Figure 13: Comparison of approved (top) and proposed (bottom) street wall heights and upper level setbacks for former David Jones building within Stage 1 looking south east from the corner of Hunter and Perkins Streets.

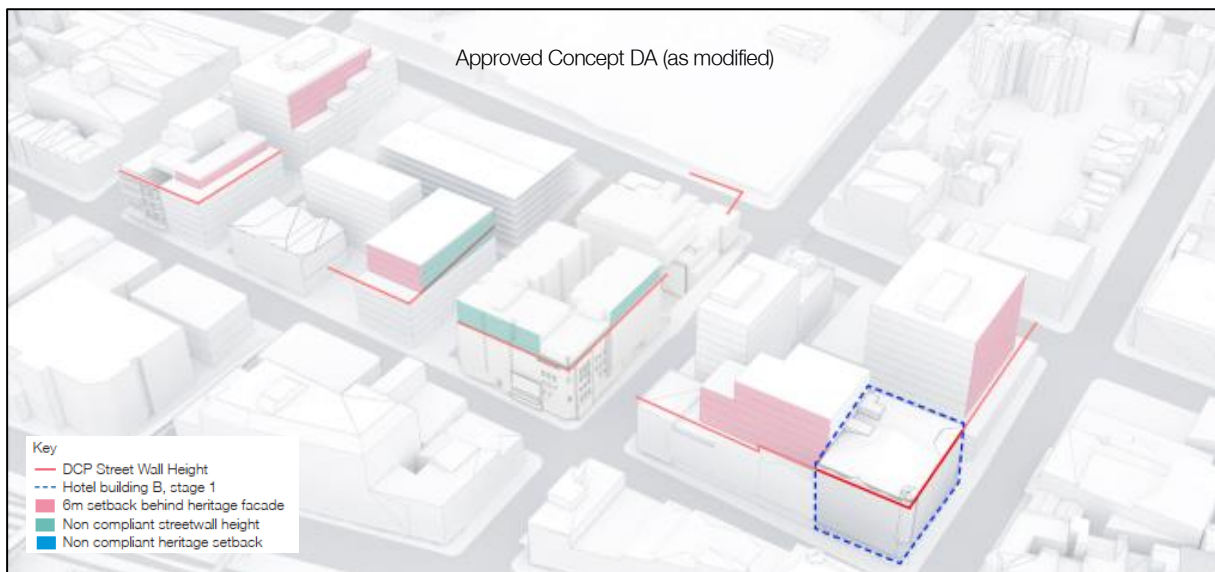
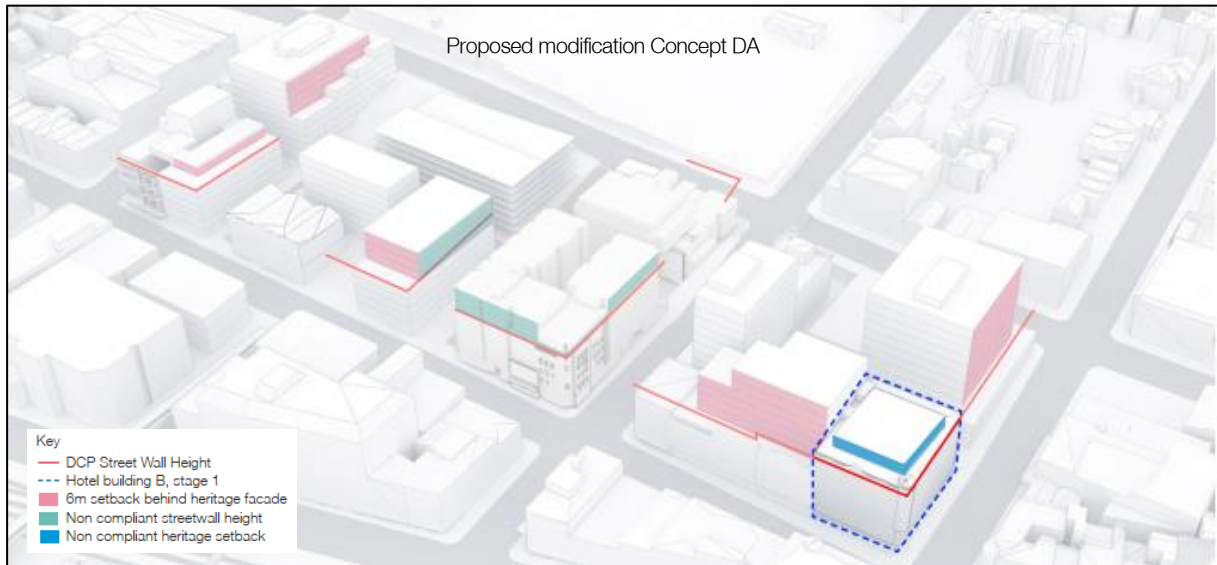
Figure 13 and 14 illustrates provide a 3D comparison of the approved and proposed building envelope above the heritage façade of former David Jones building in relation to Conditions 12 and 13.

The street wall heights and upper level setbacks are summarised below. As the proposal continues to retain and adaptively reuses the existing heritage building the street wall heights are largely retained, other than for part of Perkins Street as described in Table 4 below.

Figure 16: Long Section through the Block 1 (Stage 1) with modified building envelope of the Former David Jones Building 2 (Source: SJB Architects)

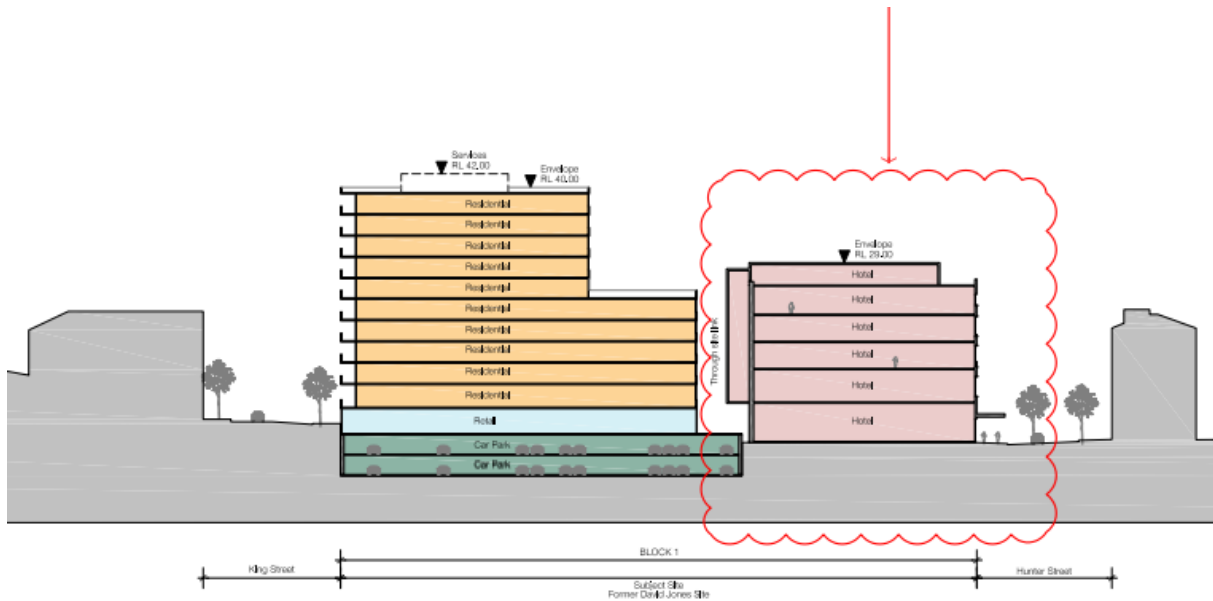
- The building envelopes are proposed to be altered for Stage 1 from the approved envelopes as described below:
- The provision of an additional storey to the former David Jones building increasing the height from part five (5) and six (6) storeys to part six (6) and seven (7) storeys; and
 - A rear addition to the former David Jones building.

Figure 20: Comparison of approved (top) and proposed (bottom) configuration of through-site link at ground level.

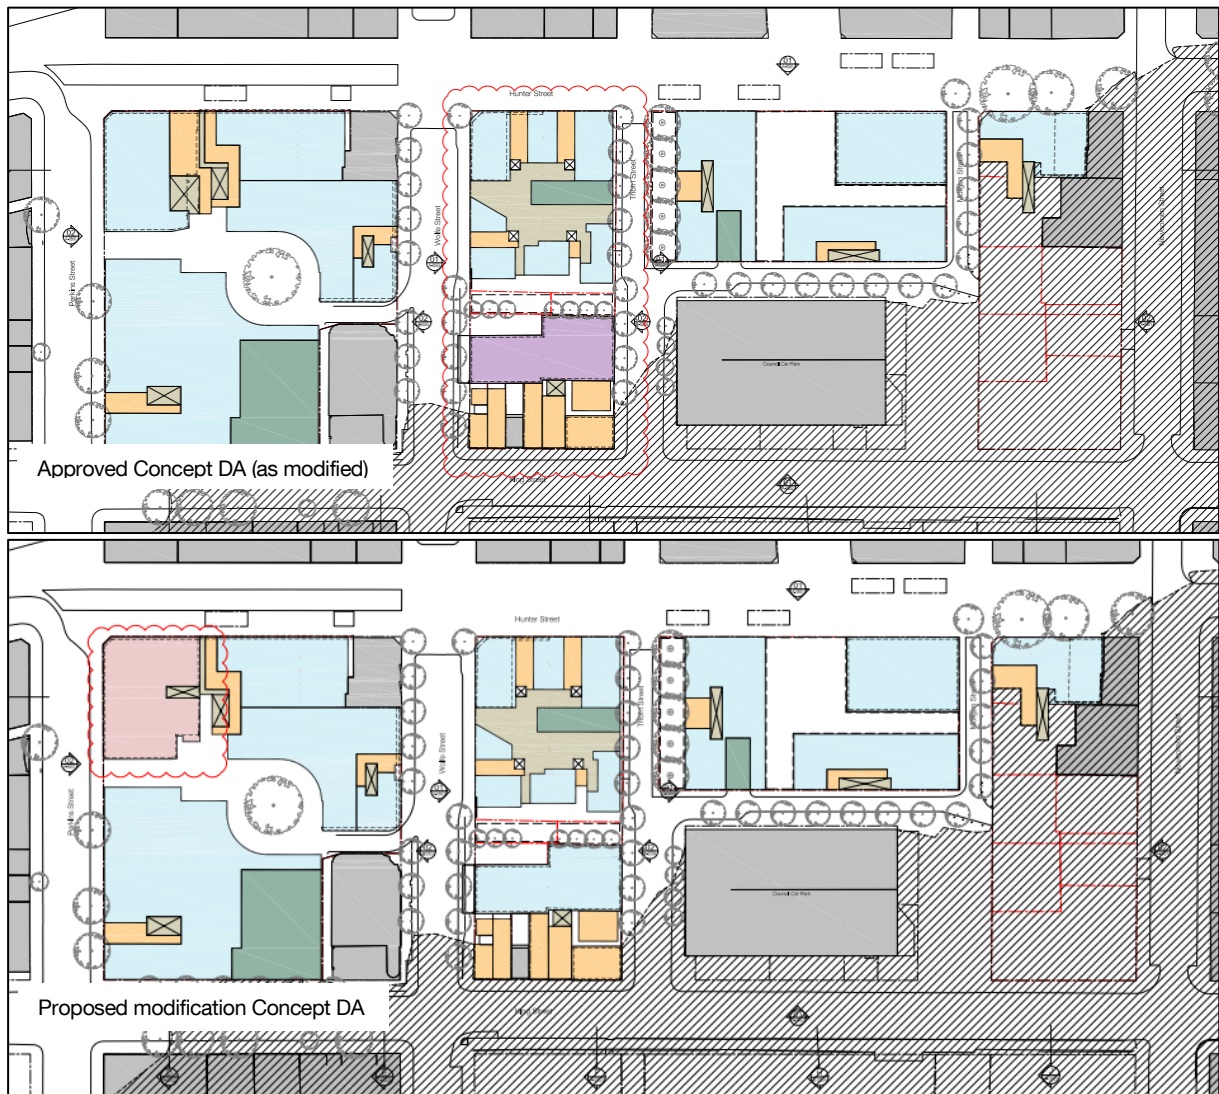
The proposal maintains the pedestrian public access linkages identified within the approved Concept DA, this includes the publicly accessible pedestrian link between Perkins Street and Wolfe Street as illustrated in Figure 19, thereby maintaining the approved public access, movement and circulation. At the ground plane, the configuration of the laneway is largely unchanged, however above ground the width of the laneway has been narrowed. This is attributed to the rear addition to the building envelope of the former David Jones building. The approved and proposed laneway configuration at and below ground is illustrated in Figure 20 and 21 below.
